AMENDMENTS TO THE DRAWINGS

Attached hereto are 2 sheets of corrected drawings that comply with the provisions of 37 C.F.R. §1.84. The corrected formal drawings incorporate the following changes:

FIG.4

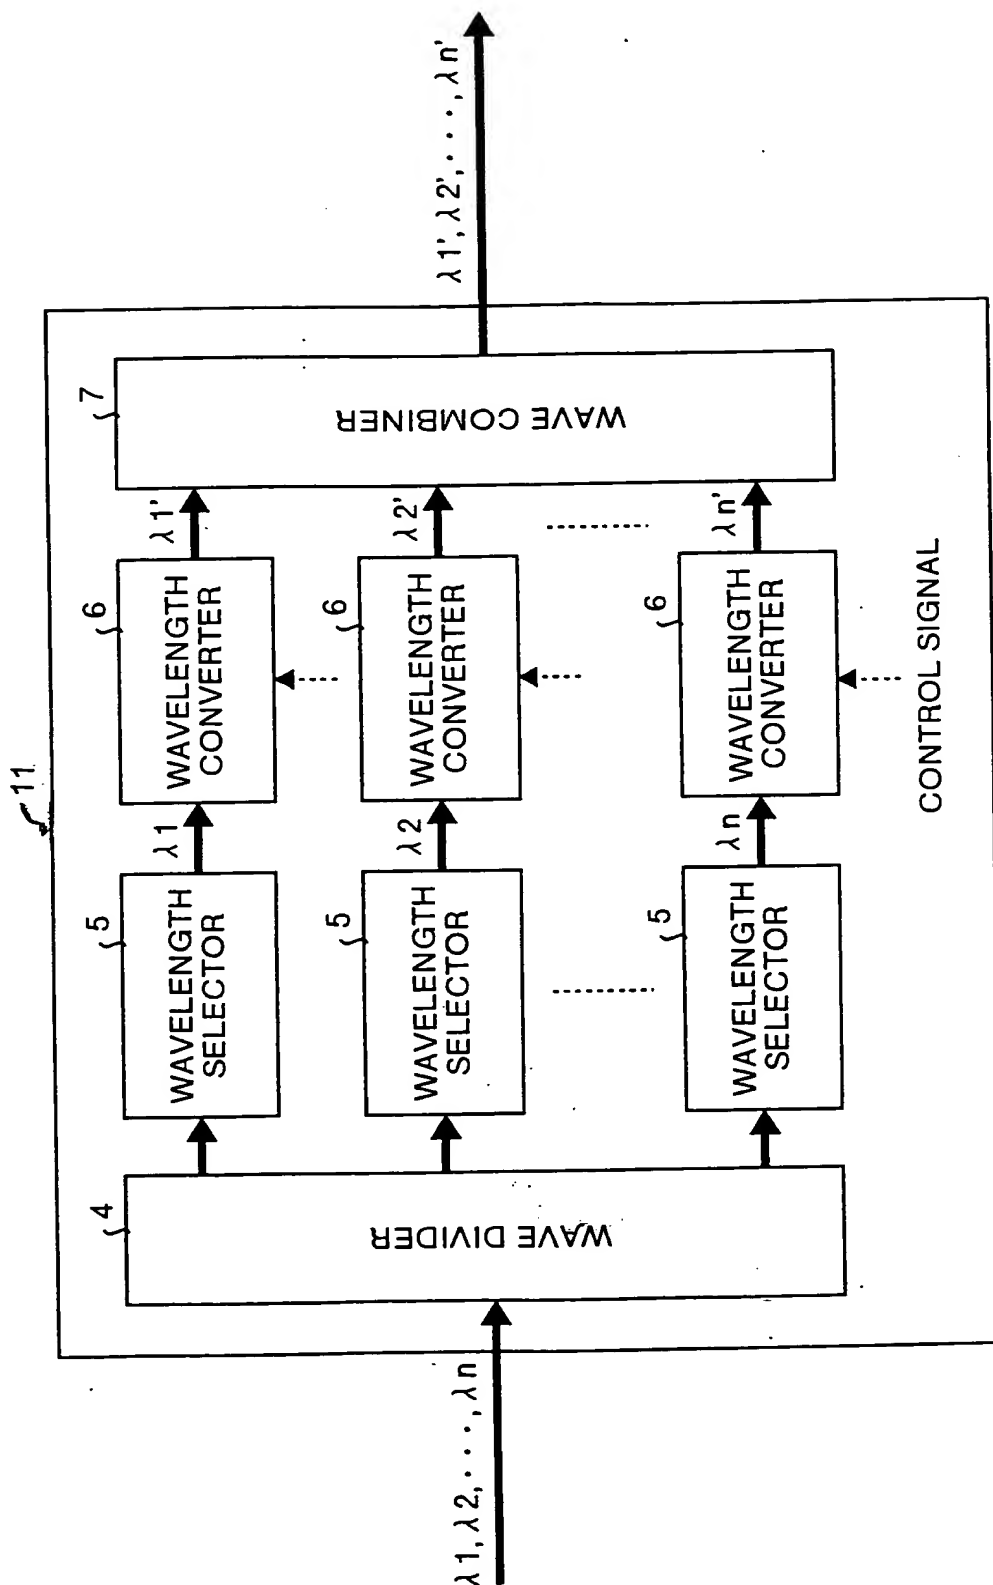
- In Figure 4, the optical repeater has been renumbered to be "11" to be consistent with the specification (see e.g. page 4, line 16 of the specification); and
- In Figure 9, the wavelength converting element has been renumbered from "11" to "105" to avoid repetition of element numbering - the optical repeater of Figure 4 is numbered as "11". Note that the specification has been amended accordingly to be consistent with the new number.
